Airworthiness Directive Schedule

De Havilland DH83 Series (Fox Moth)

26 April 2018

*** DCA/DH83/105B Croydon Manufactured Wing and Aileron Spars – Flight Limitation**

Figure 1 - De Havilland Design:

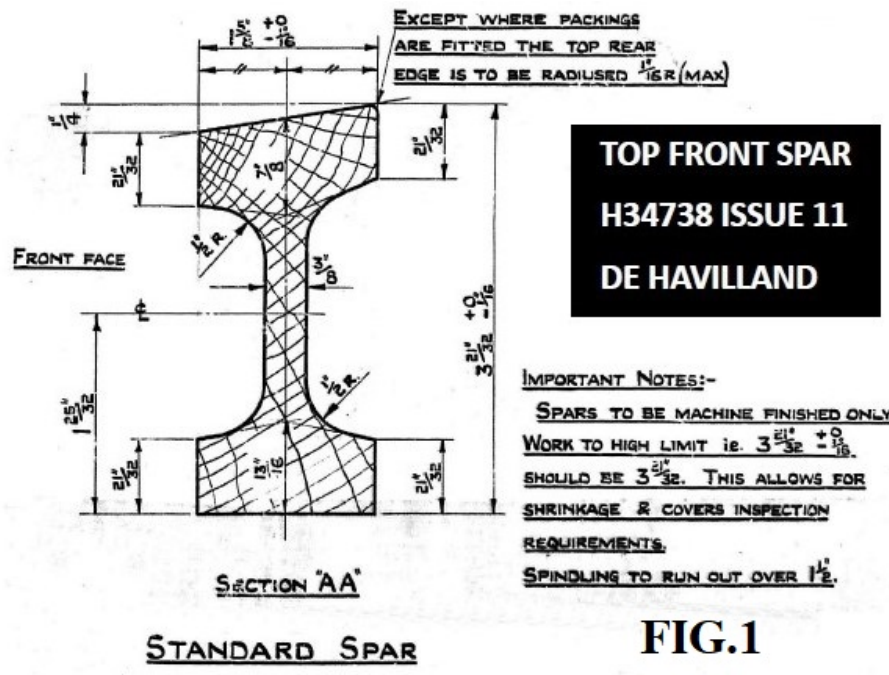
1. If an affected wing or aileron spar is found installed, then aerobatics or other flights involving high load factors, including flight in turbulent conditions are prohibited until requirement 2 of this AD has been accomplished.
2. If an affected wing or aileron spar is found installed, accomplish the following:
 - 2.1. If an affected aileron spar part number is found fitted, then conform the spar to the approved type design per the original de Havilland design, or replace the affected aileron spar, before further flight.
 - 2.2. If an affected mainplane/wing spar is found fitted, then inspect the forward and the aft faces of the affected spars in four places, and determine if the spar section properties (i.e. area, shape) conform to the approved type design per the original de Havilland design shown in Figure 1.

If the wing spar section properties conforms to the original de Havilland design shown in Figure1, then no further action is required, and the previous flight limitations can be removed.

If the wing spar section properties do not conform to the original de Havilland design shown in Figure1, then accomplish requirement 3 of this AD, before further flight.
3. Inspect the affected wing spar and compare the spar section properties with the Croydon spar profile shown in Figure 2.

Figure 2 – Croydon Spar Profile:

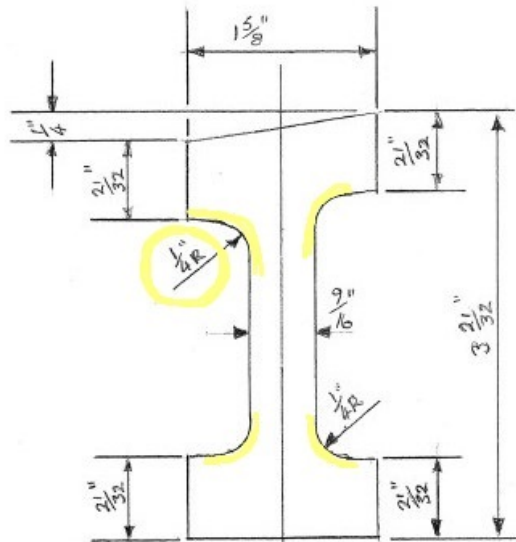
If the wing spar section properties (minimum spar web radius and dimensions) are found not less than that shown in Figure 2, (i.e. the inside radii of the spar cut-outs

are found not less than 0.25 inches as shown in Figure 2), then no further action is required, and the previous flight limitations can be removed.

If the wing spar section properties (minimum spar web radius and dimensions) are found less than that shown in Figure 2, (i.e. the inside radii of the spar cut-outs are found less than 0.25 inches as shown in Figure 2), then remove the affected spar from service, and replace with a serviceable part, before further flight.

Report any machined spars with section properties less than that shown in Fig.2 to the CAA by completing a CA005 Defect Report form. Please provide the spar part and serial numbers, and a copy of the release documentation. The form can be obtained from CA005@caa.govt.nz. The completed form can be emailed to the CAA at http://www.caa.govt.nz/Forms/CA005D_Form.pdf
